Aircraft
Specialties Co.**SERVICE BULLETIN NO. 1**

PART NAME: Air Filter Assembly
PART NUMBER: BA-8110 (With Welded in Retainer)
STC NUMBER: STC - SA71GL

SERVICE BULLETIN # 7
EFFECTIVE DATE: MARCH 1, 1985

INSTALLATION INSTRUCTIONS

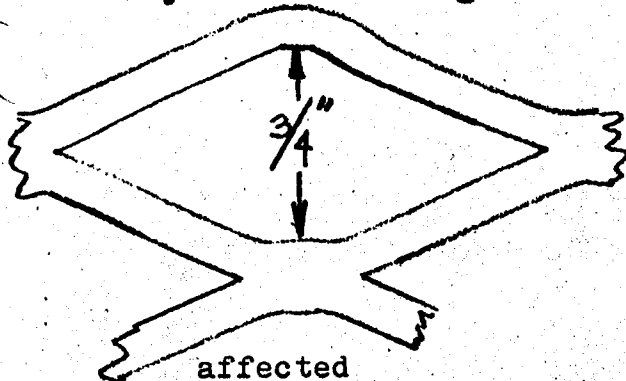
INSPECTION: Remove element and inspect retainer. If retainer has large
aluminum diamond shaped opening 1-3/4" x 3/4" (ones that you can
stick your finger through), then the filter assembly is affected
by this bulleting.

STEEL this type screen
is not affected by bulletin

COMPLIANCE: Order Kit that corresponds to affected filter assembly.

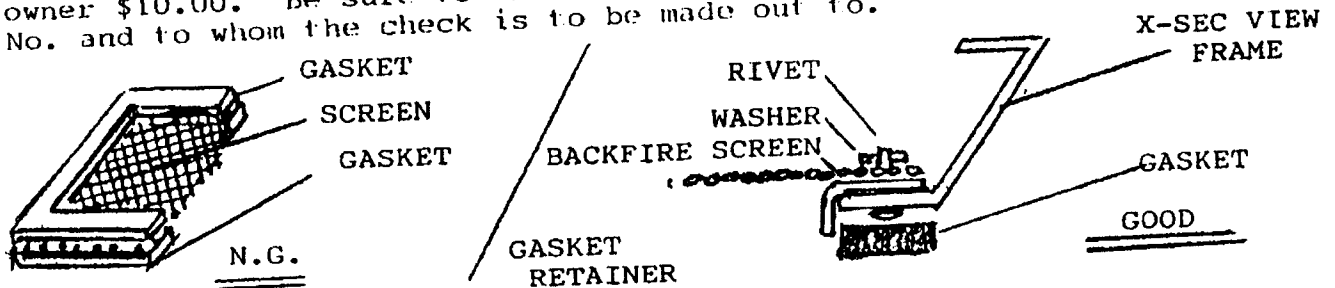
Prior to August of 1981 we manufactured the BA-8110 filter assembly with a gasket on both sides of the backfire screen. August 1981 and after the filter assemblies have been manufactured with the backfire screen riveted inside the assembly and the addition of gasket retainer strips to prevent any chance of the gasket migrating into the induction system. We would like to get all of these older BA-8110's up graded for added safety.

To check: Push the foam element away from either side of the frame and look to see if the screen is riveted into the box. If it is, then it is OK.

If the inspection reveals an affected filter screen (a screen that is sandwiched with two gaskets) then order Kit Part No. BA-81C.

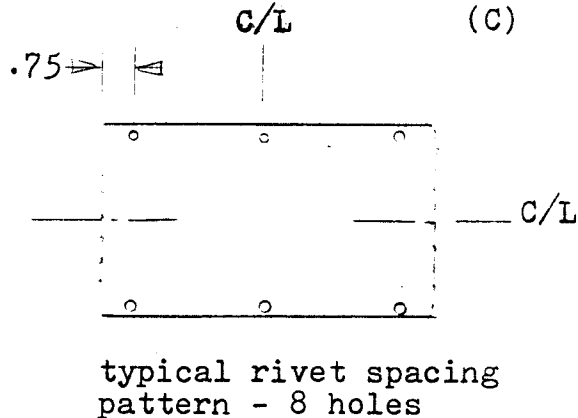
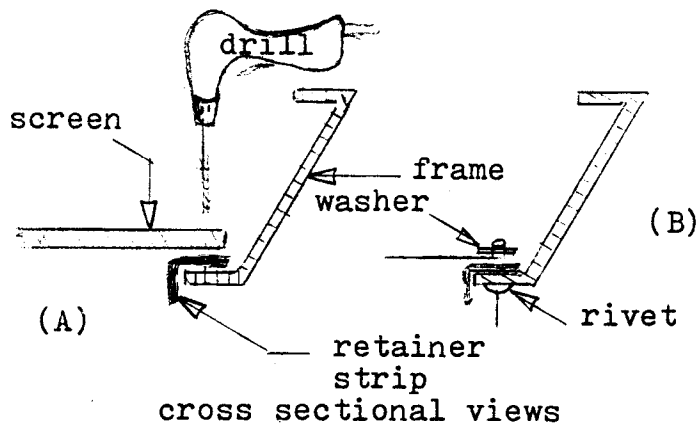
Step 6. Start with the open angle end. Diagram (A) - Use a 1/8" drill and drill a hole through the screen, the retainer strip and the frame. Next insert a SSD-4-3 rivet through the frame, retainer and screen, and then place a AN 960-6L washer over the rivet and rivet in place. Diagram (B) - Next drill the 2 other holes and rivet. See rivet pattern shown in diagram (C) below.
